- **Request for Administrative Approval – Temporary Lay Down Area**

To: Erick Veerkamp
From: Mark Kehoe
CC: Chris Marxen
Date: 8/24/2011
Re: GWF Tracy (08-AFC-07) Temporary Lay Down Area Expansion

GWF TRACY COMBINED CYCLE POWER PLANT TRACY, CALIFORNIA

EROSION AND SEDIMENT CONTROL PLAN

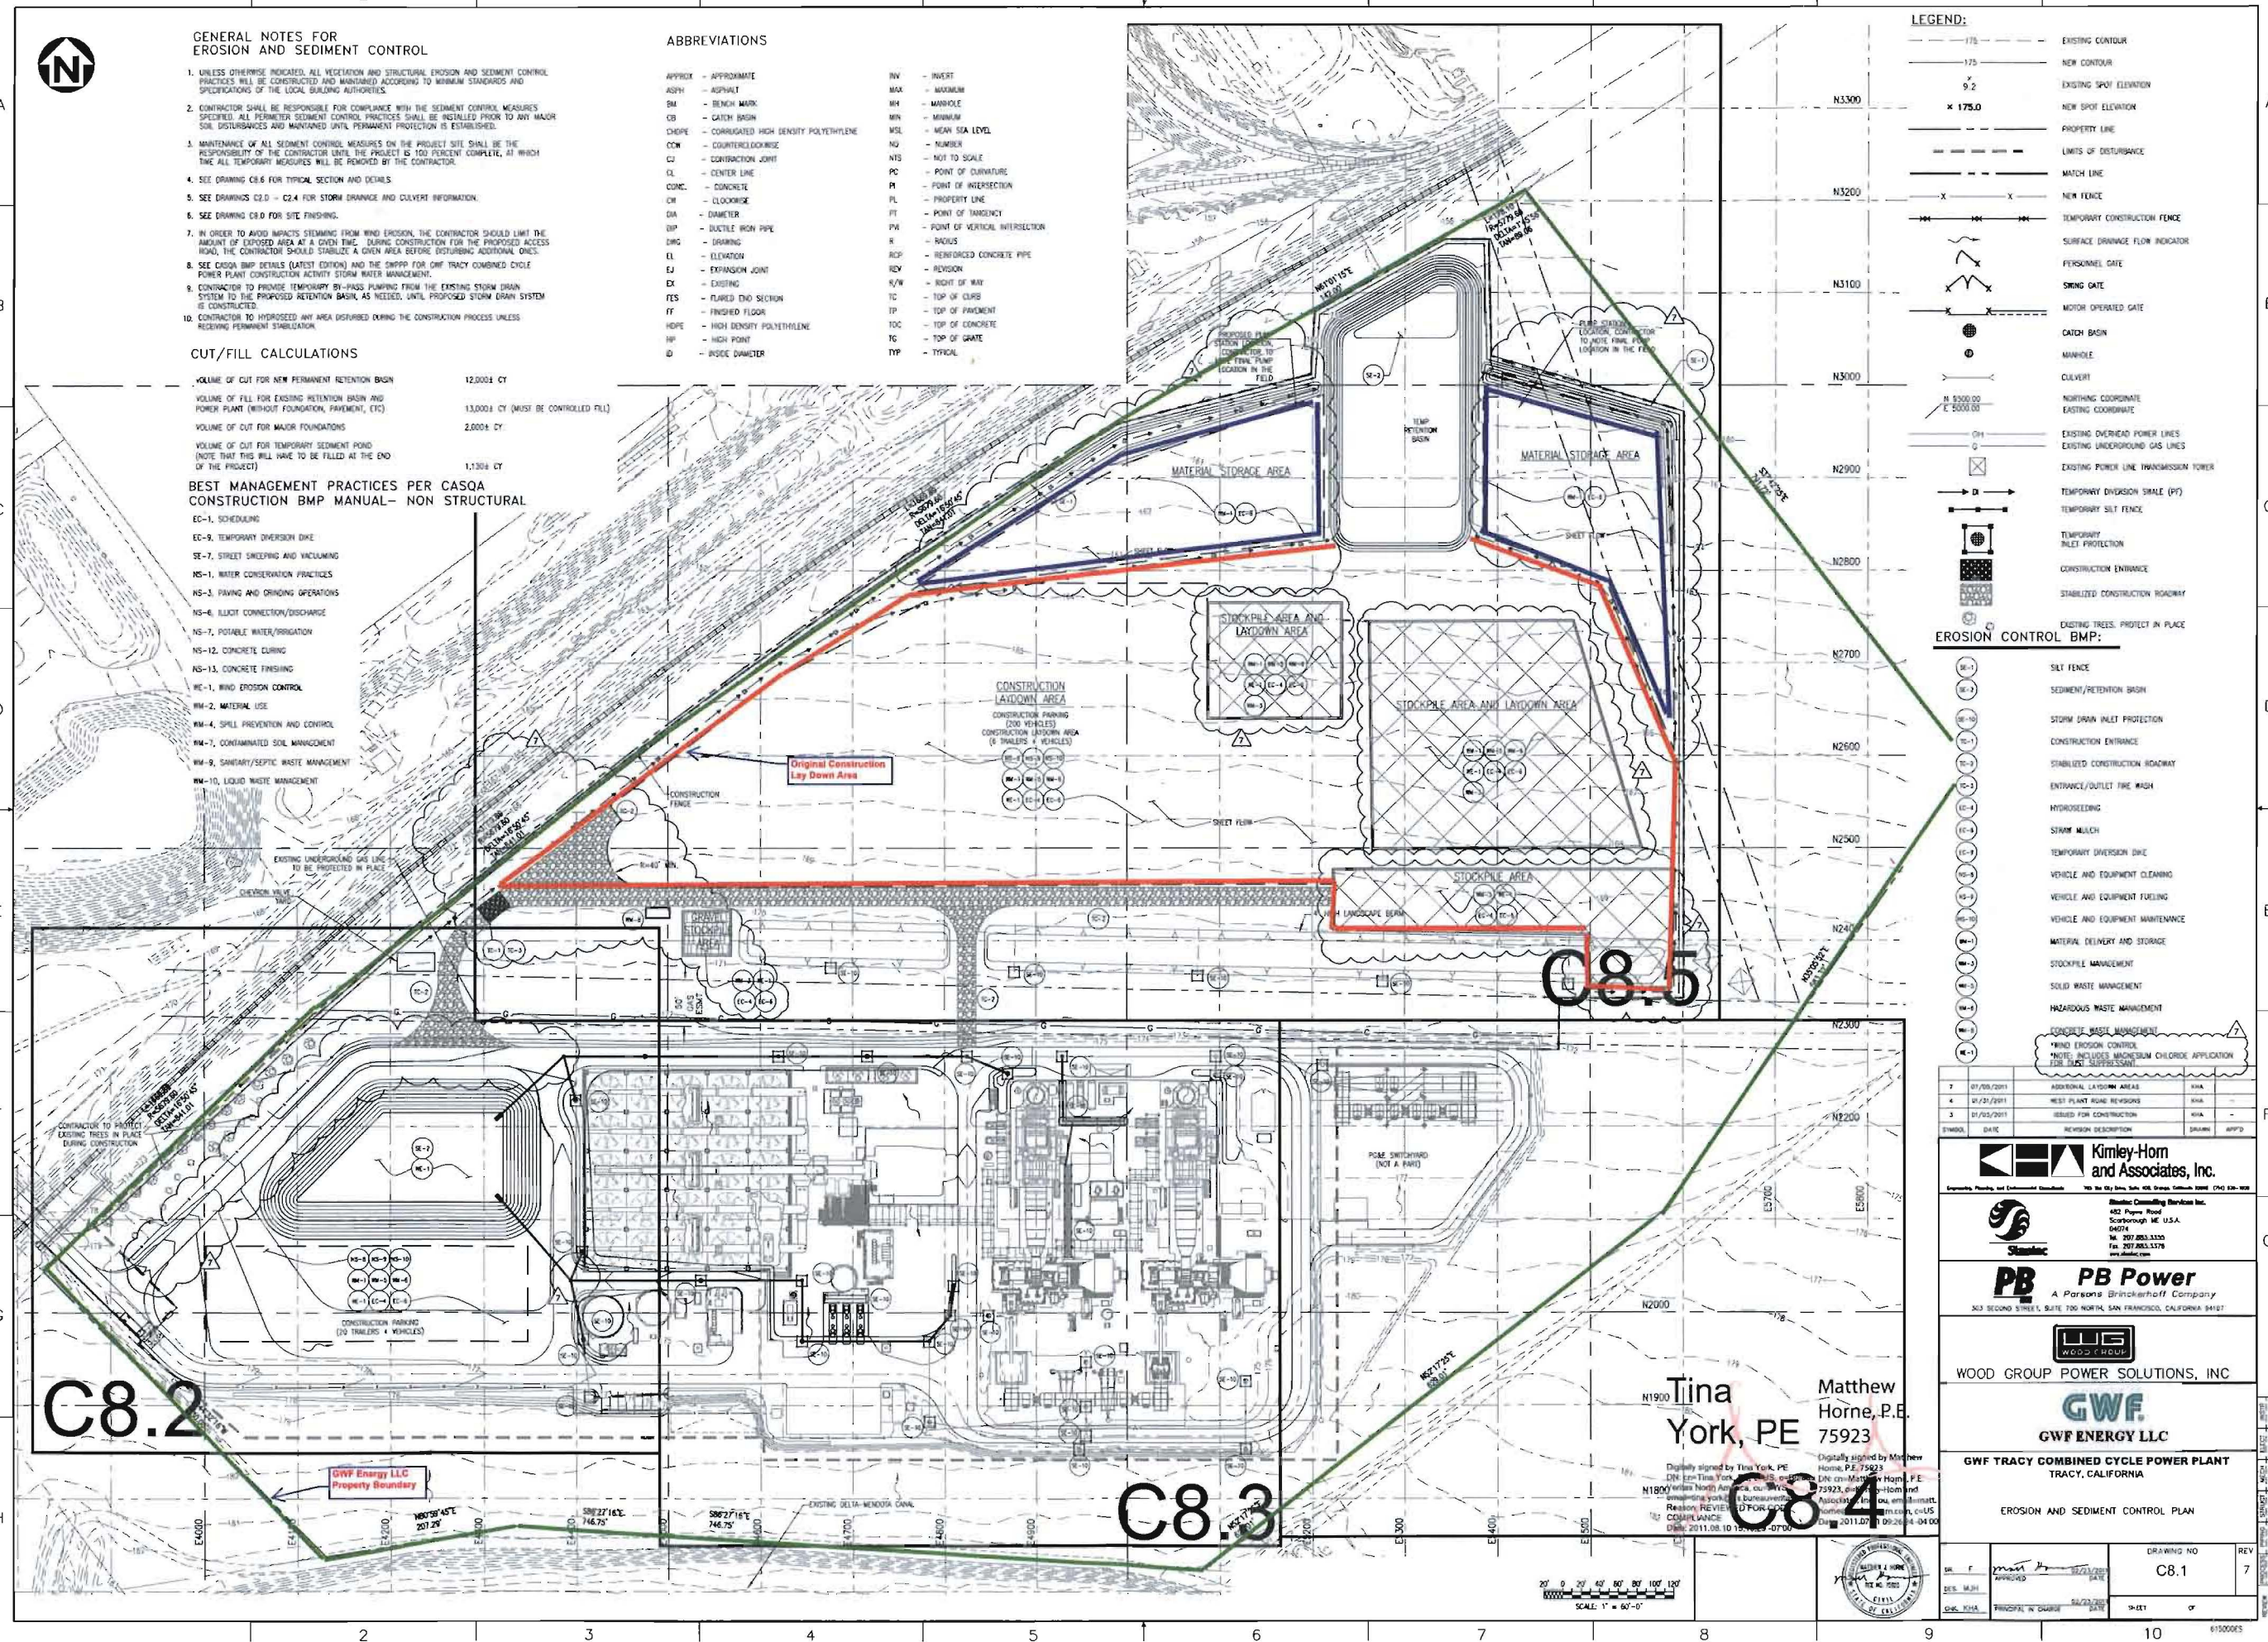
Figure 1 (see attached) provides a drawing that shows GWF Energy's property boundary of nominally 40 acres, the nominal 12.3 acres of original construction parking and lay down/construction area and the additional 5.45 acres of land that GWF requests be approved for construction material storage.

5. The Drainage, Erosion and Sedimentation Control plan has been revised to include Best Management Practices (BMPs) for the additional lay down area and as such will prevent any surface water accumulation from storm events from draining onto adjacent properties.

- a. Bureau Veritas – North America the Chief Building Official for the project has reviewed and approved the site drainage drawings that reflect the changes to the lay down area.
